DFM REPORT OF

Y060-001

Part Name: UPPER_PULT

Mold Number: **Z060**

Part Layout

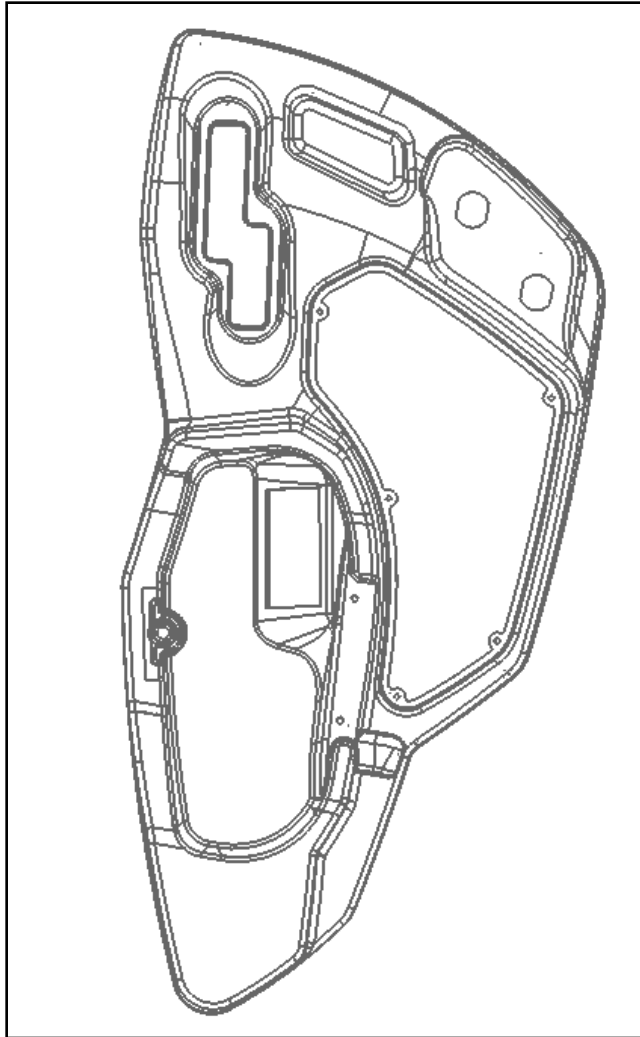
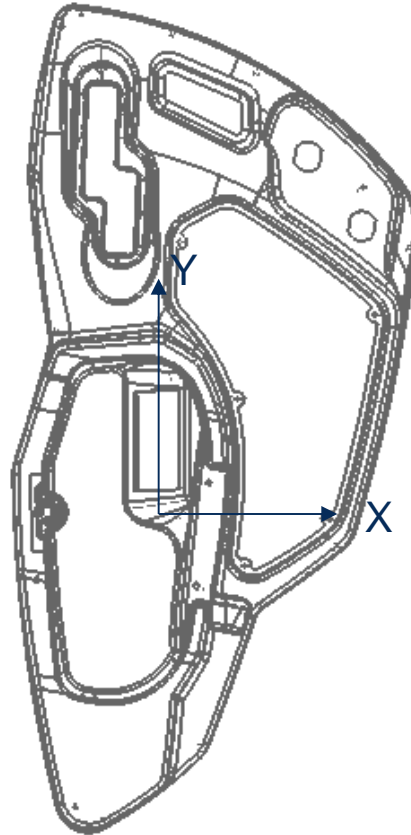
Need to show part layout to avoid customer misunderstanding our proposal

Notes: this is very rough layout, but it is a Useful guidance for our tool designer.

Mold size is 900x600MM,

Produce in a BM 650T machine

Gate layout

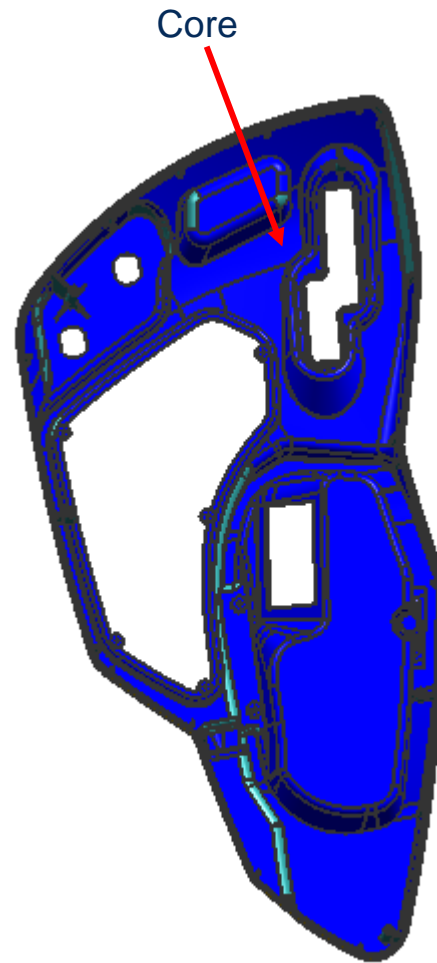
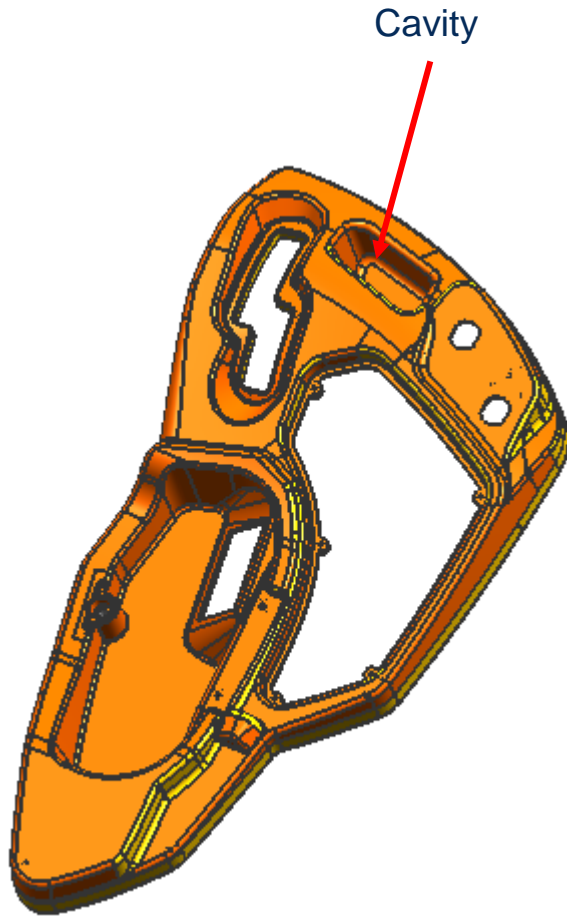
We found one drop is not enough to fill this part, 2 drops is needed, please confirm. If you want one drop, could you please provide hot runner drawing for our reference? Thank you.

Parting line

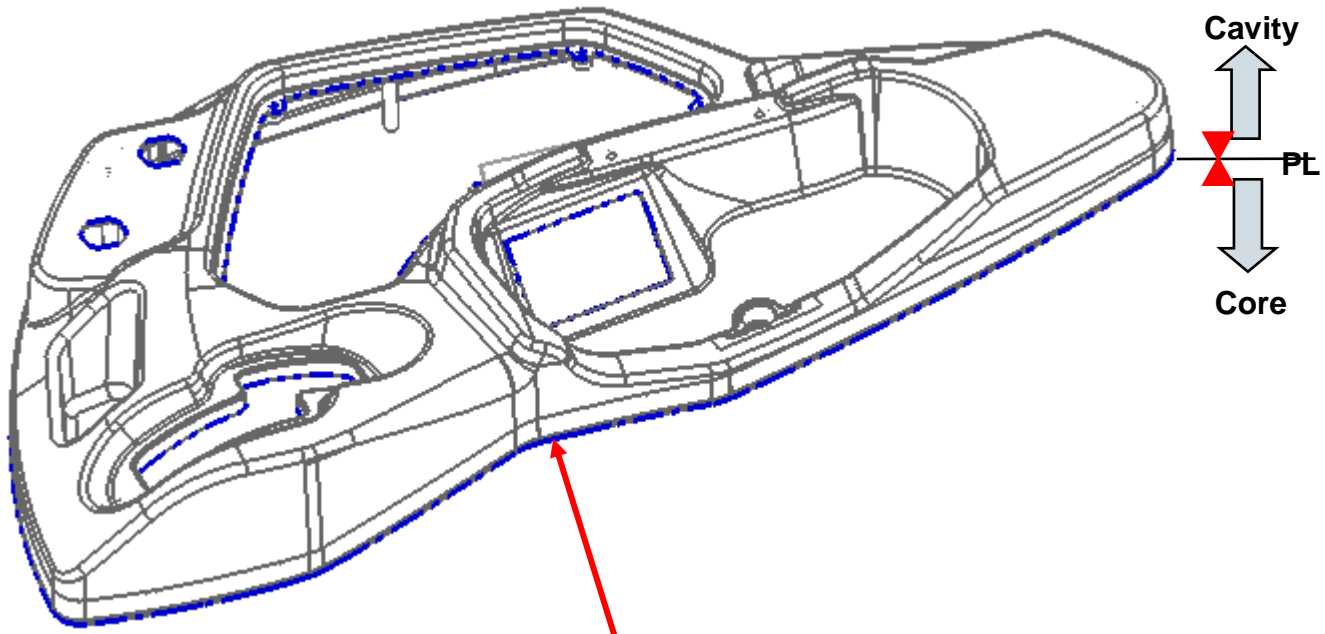
The blue line is parting line

Notes: please advice any concern on propose parting line.

Parting line

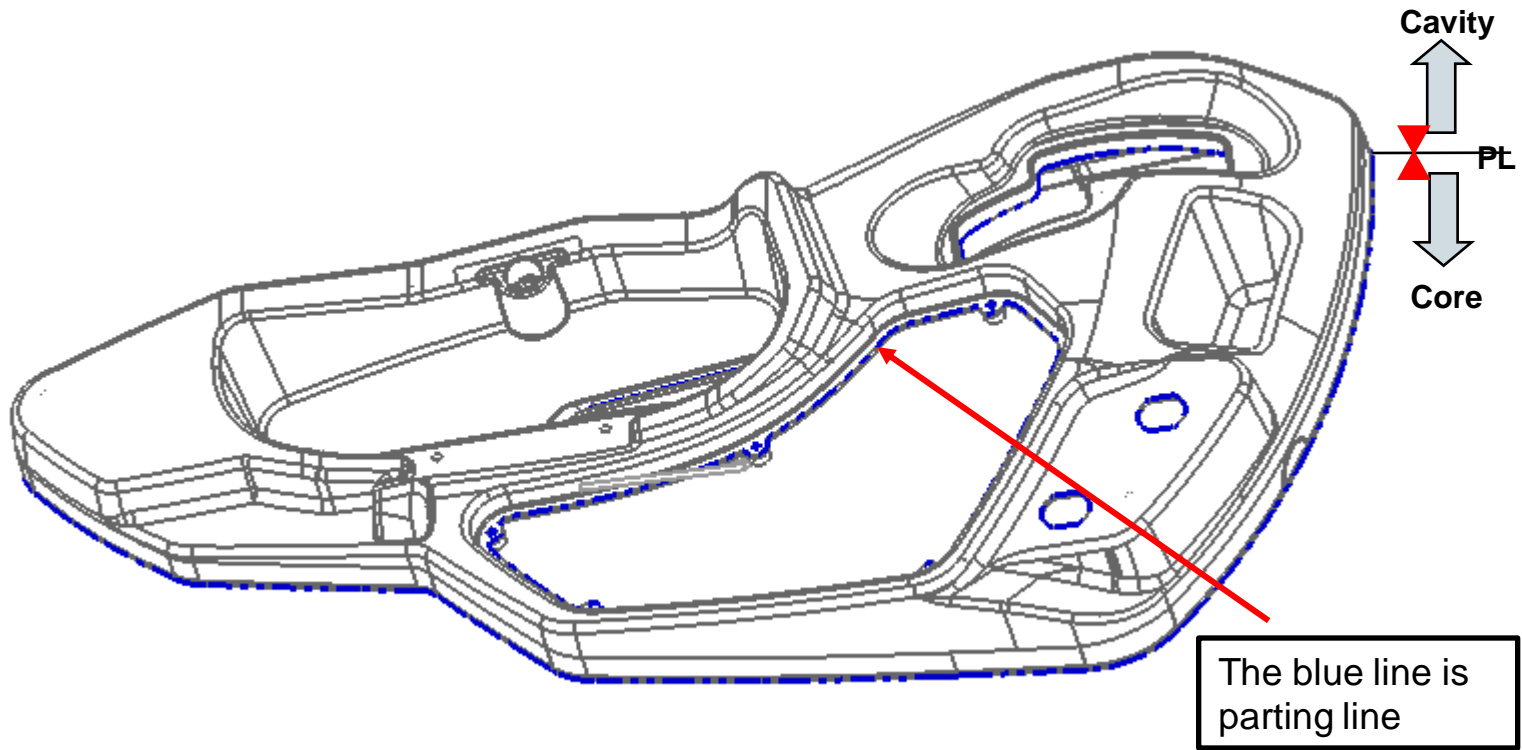
Notes: please advice any concern on propose parting line.

Parting line

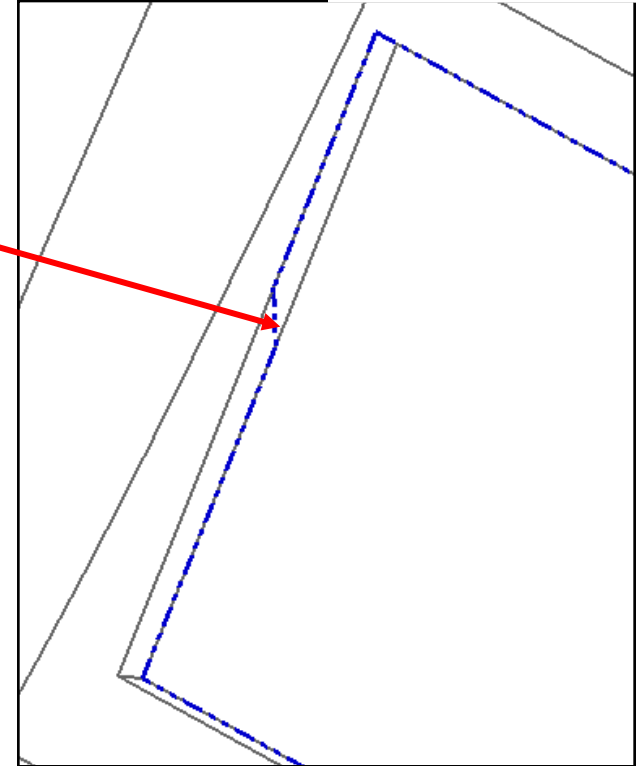
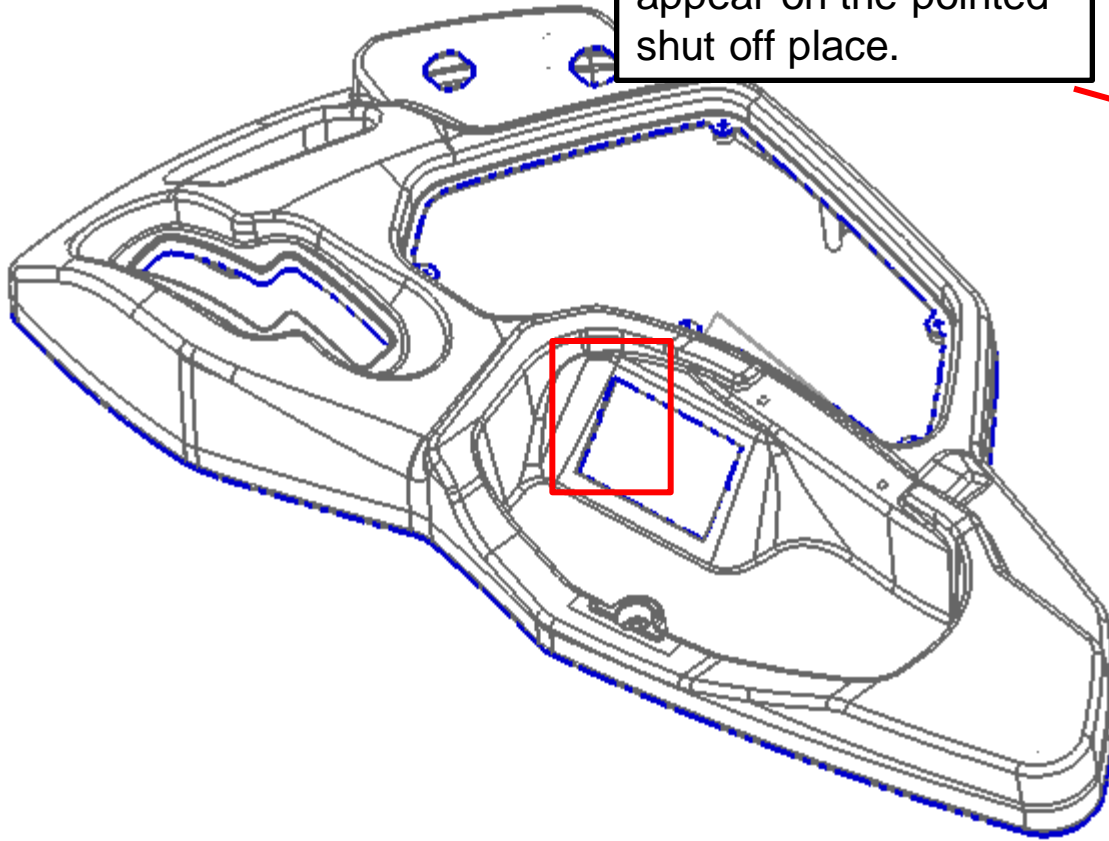
0.3mm mismatch will appear on the pointed shut off place.

Notes: please advice any concern on propose parting line.

Insert parting line on cavity

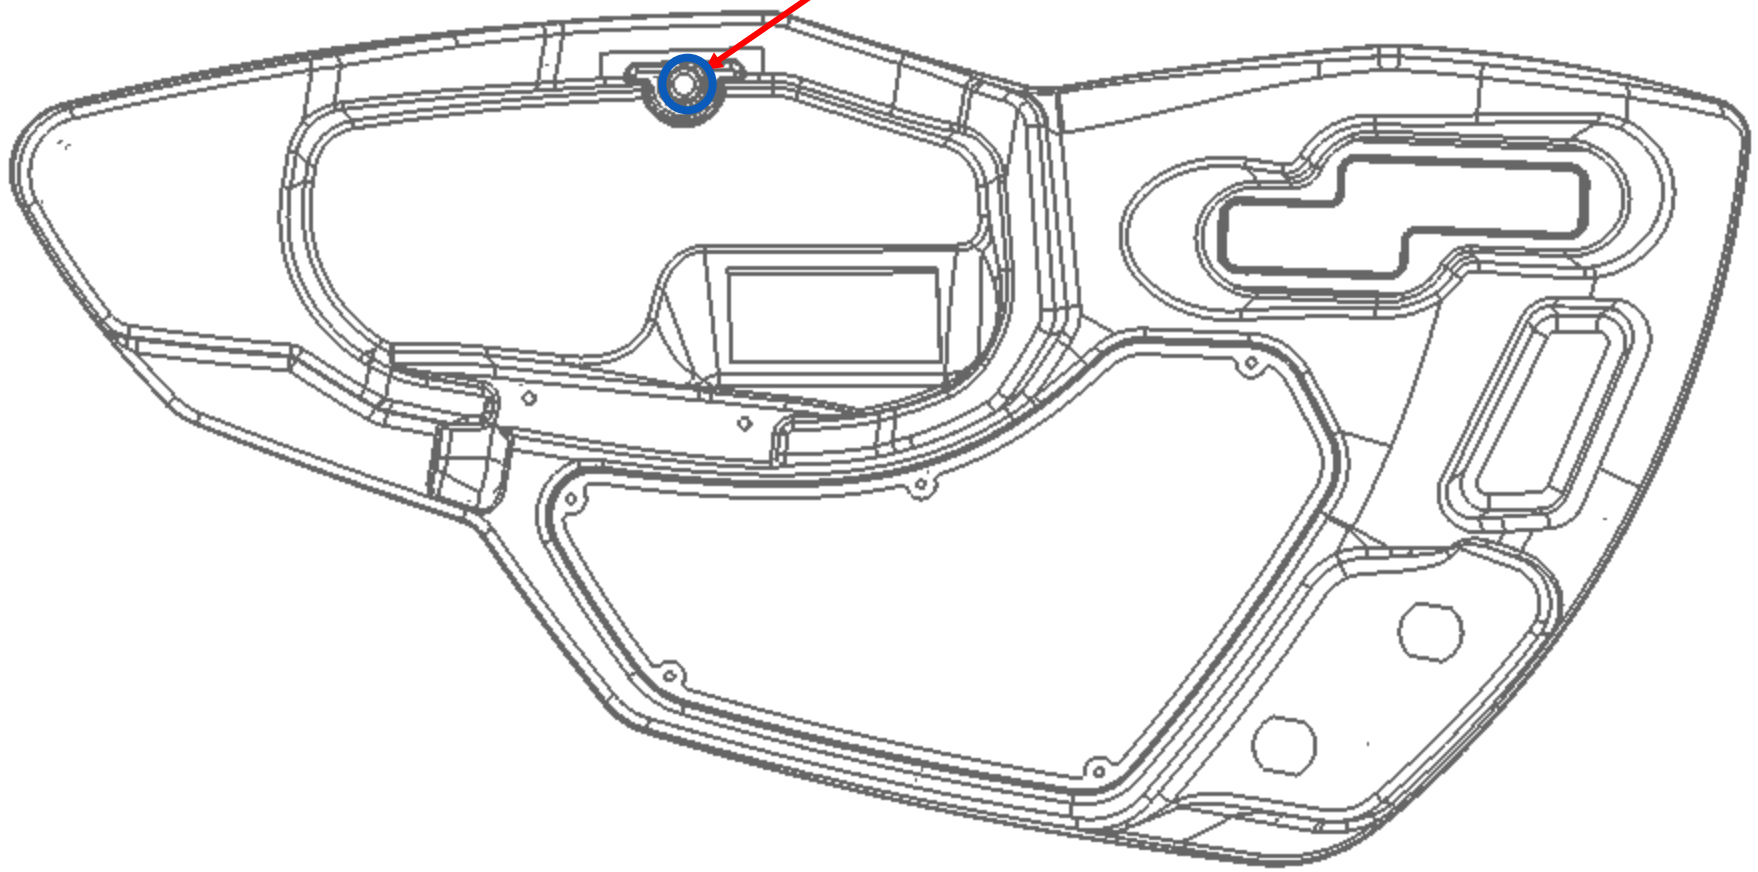
Notes: please advice any concern on propose parting line.

Insert parting line on core

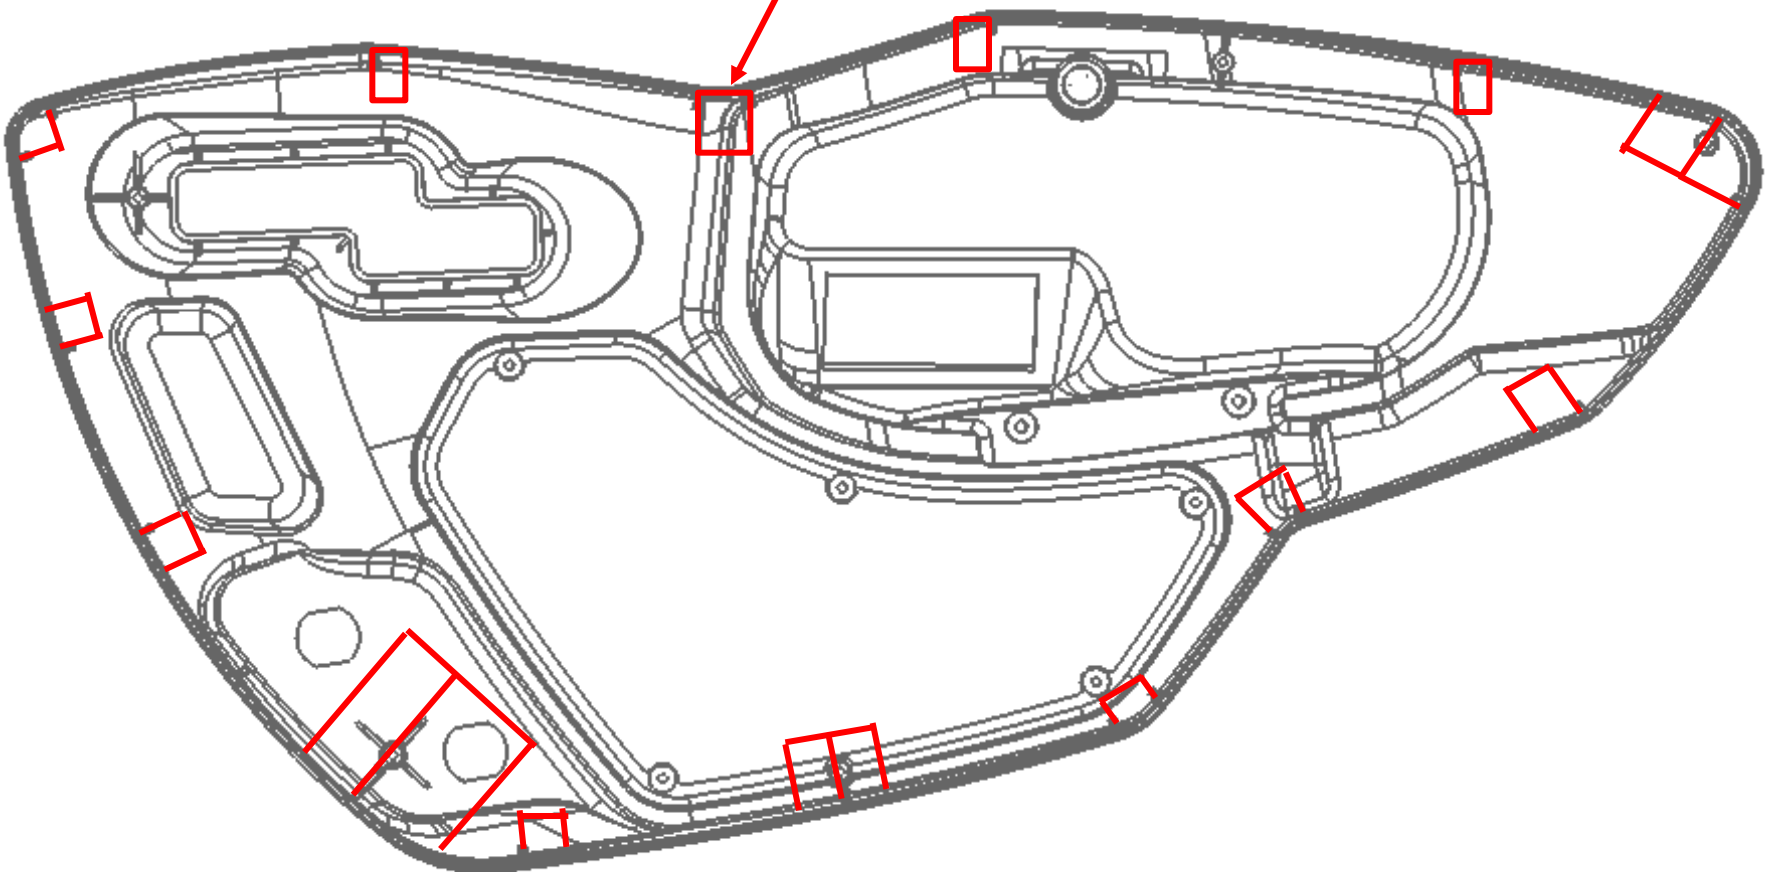
Notes: please advice any concern on propose parting line.

Core Lifter & Slider

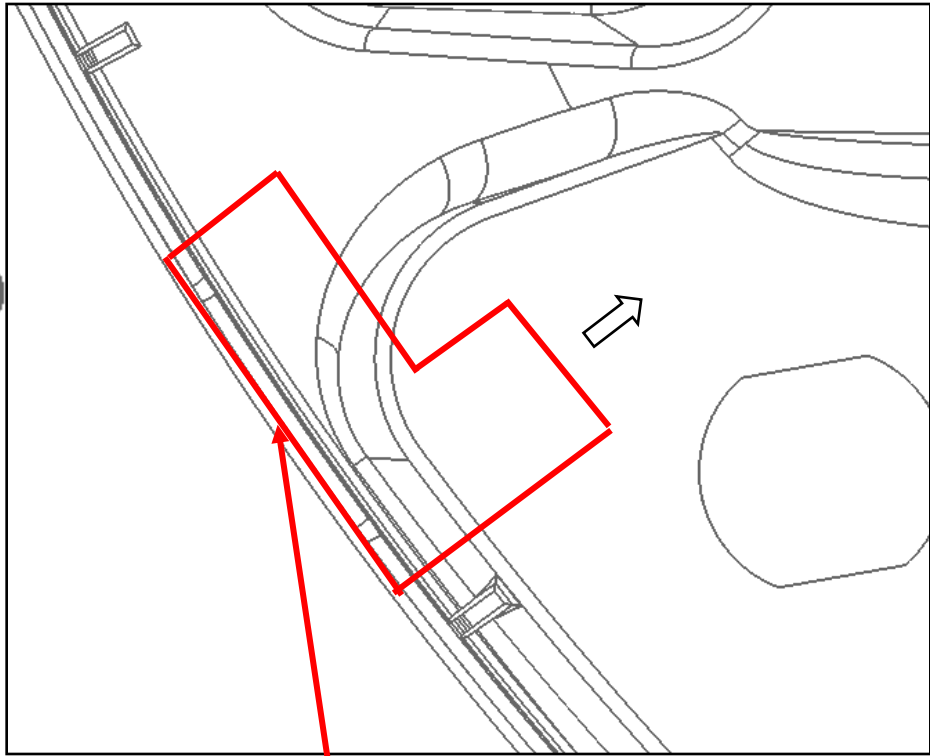
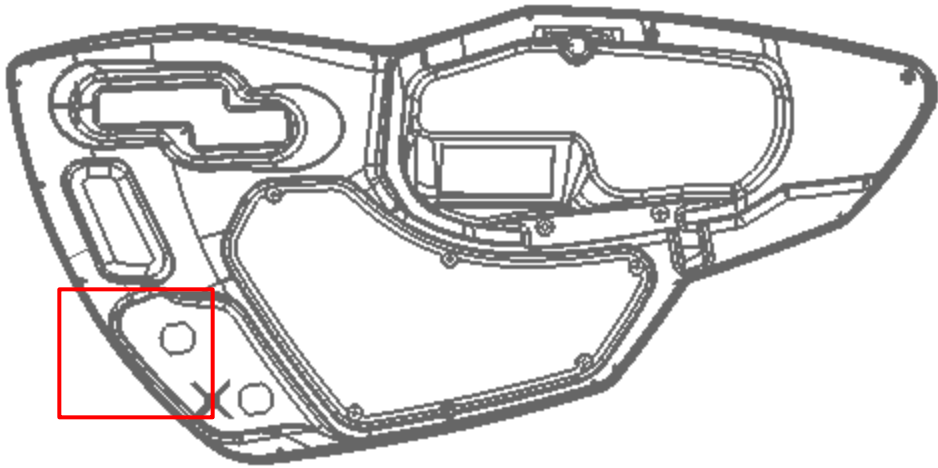
Notes: please advise any concern on witness line form by lifter.

Lifter draft angle

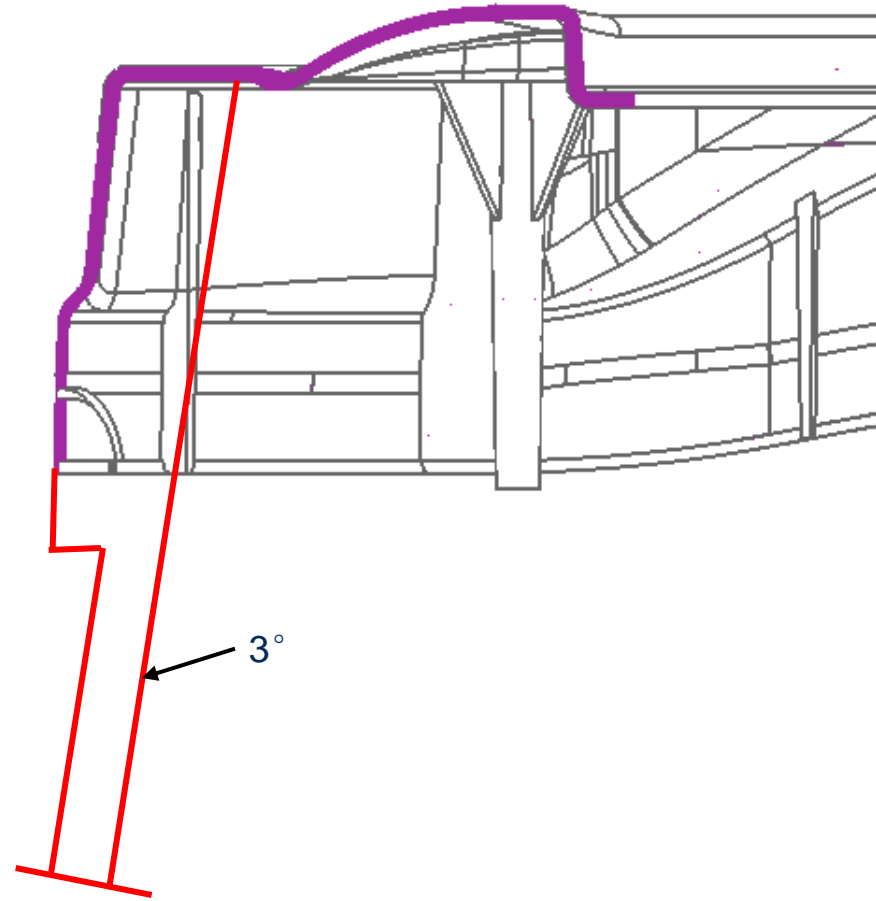
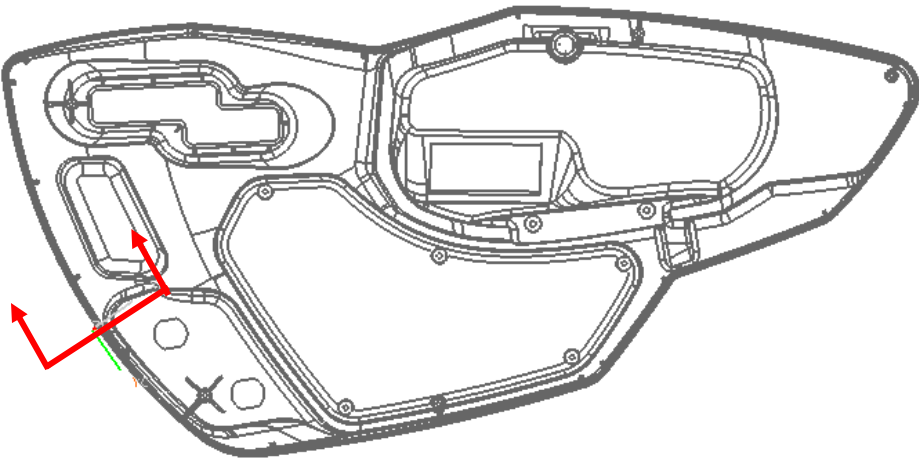
Please make lifter side draft.	
Color	Propose Draft angle
